Changes in the Aprisa SR+ 896 MHz

Revision 1

October 23, 2025

FCC ID:	UIPSQ896M141
ISED Radio Cert. No.:	6772A-SQ896M141
HVIN:	SQ896M141

Figure 3: Old PCA layout bottom view

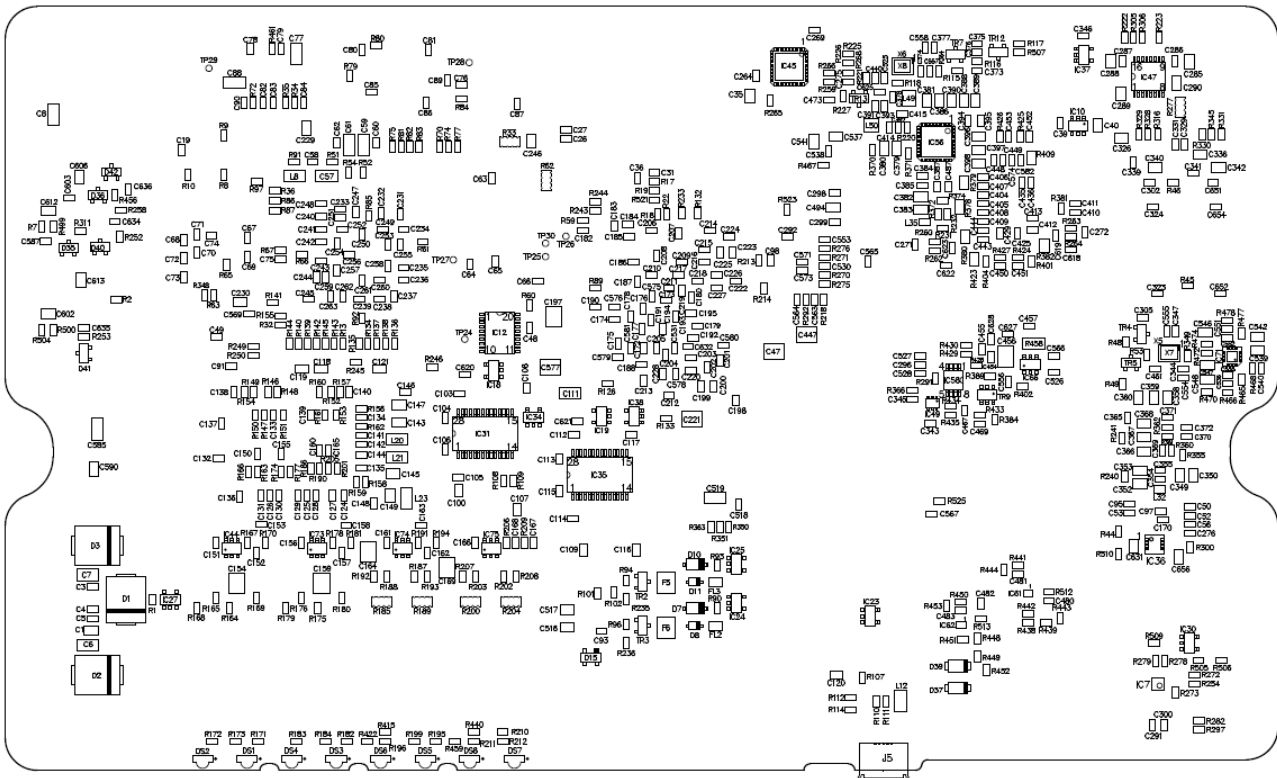
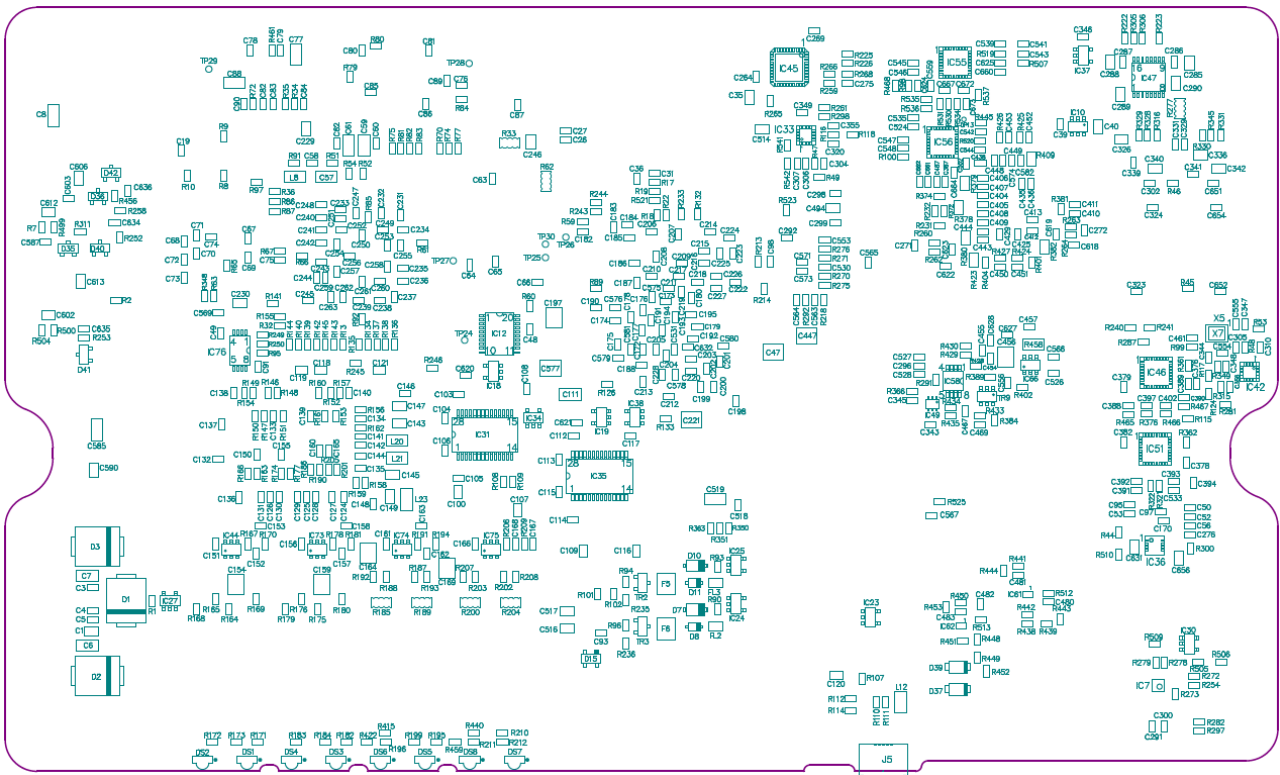
Changes in the Aprisa SR+ 896 MHz associated with the change to the transmitter and receiver synthesizers under C2PCPX. Changes required due to the obsolescence of the original synthesizer component. No additional functionality has been added with this change.

Both transmitter and receiver synthesizers are located on the bottom of the Printed Circuit Assembly (PCA), however top layouts and photographs have been included for completeness.
